We have received the reviews of two referees on our paper, titled: **Hydrogeological controls on the spatio-temporal variability of surge-induced hydraulic gradients along coastlines: implications for beach surface stability** (A. Paldor et al.). We thank the referees for their valuable feedback, which we believe improved the paper. Below is a list of the comments (in red) and our respective replies (in black). Text cited from the manuscript is in black italicized, with revisions highlighted in blue with tracked changes. All references to the text are to the revised manuscript with tracked-changes.

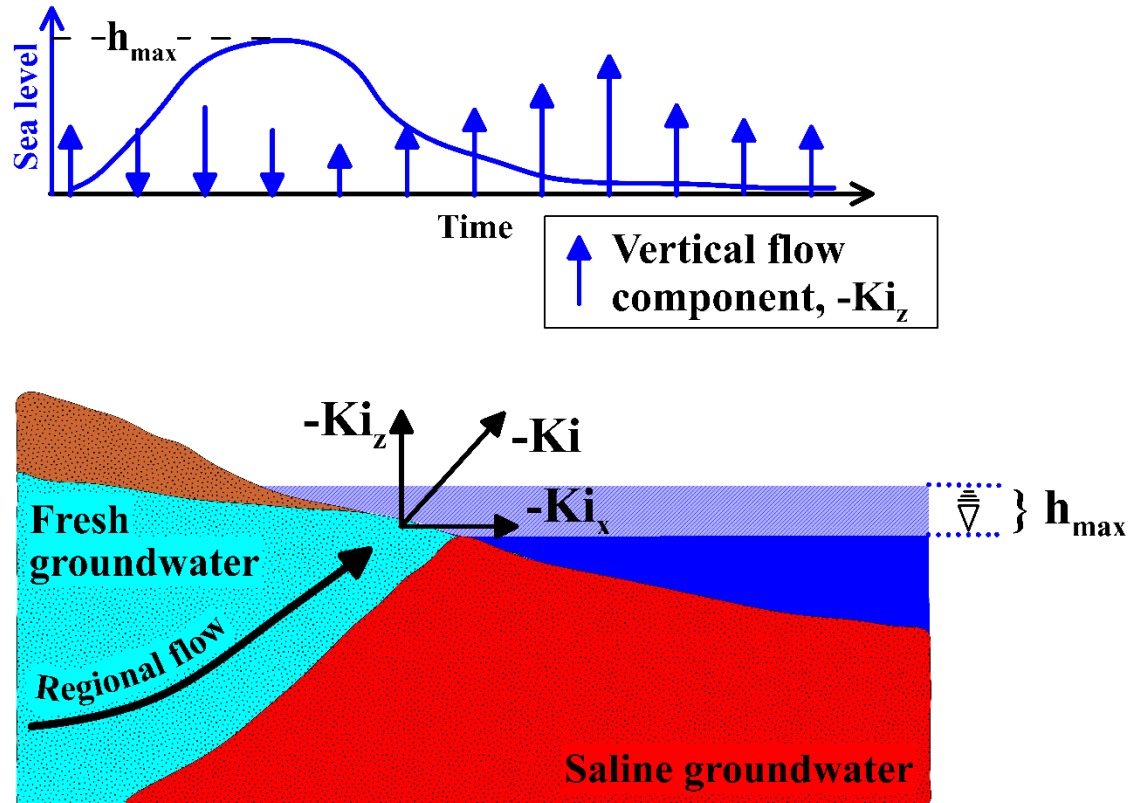
16) Line 121: *Seepage vector needs to be defined and developed more clearly. Not the same terminology as used later in either the methods or results. Assuming seepage means “specific discharge vector”? Why the magnitude? Isn’t direction important? Figure 2 could be made more consistent with the methods/equations/variables. Where is this seepage vector being calculated (especially for Fig 2)? At the top of the free surface? At some depth? Figure 2 also does not show the “magnitude of seepage component” but the actual seepage component with changing directions.*
We revised the sentence as follows (lines 130-134):
The magnitude of the hydraulic head gradient (~~Figure 2~~), which according to Darcy’s law is the magnitude of the seepage vector divided by the hydraulic conductivity, is denoted i (Figure 1). The seepage vector is the specific discharge, which is computed as the outflow vector at top nodes of the

domain. In 2D, this vector has two components – a horizontal ($-K_i$ in Figure 2) and a vertical ($-K_{i_z}$). This work focuses on the vertical component. Other variables used in the following calculations are shown in Figure 2 and summarized in Table 1.

As suggested, we also changed Figure 2 (which is now Figure 1) for consistency with the text:
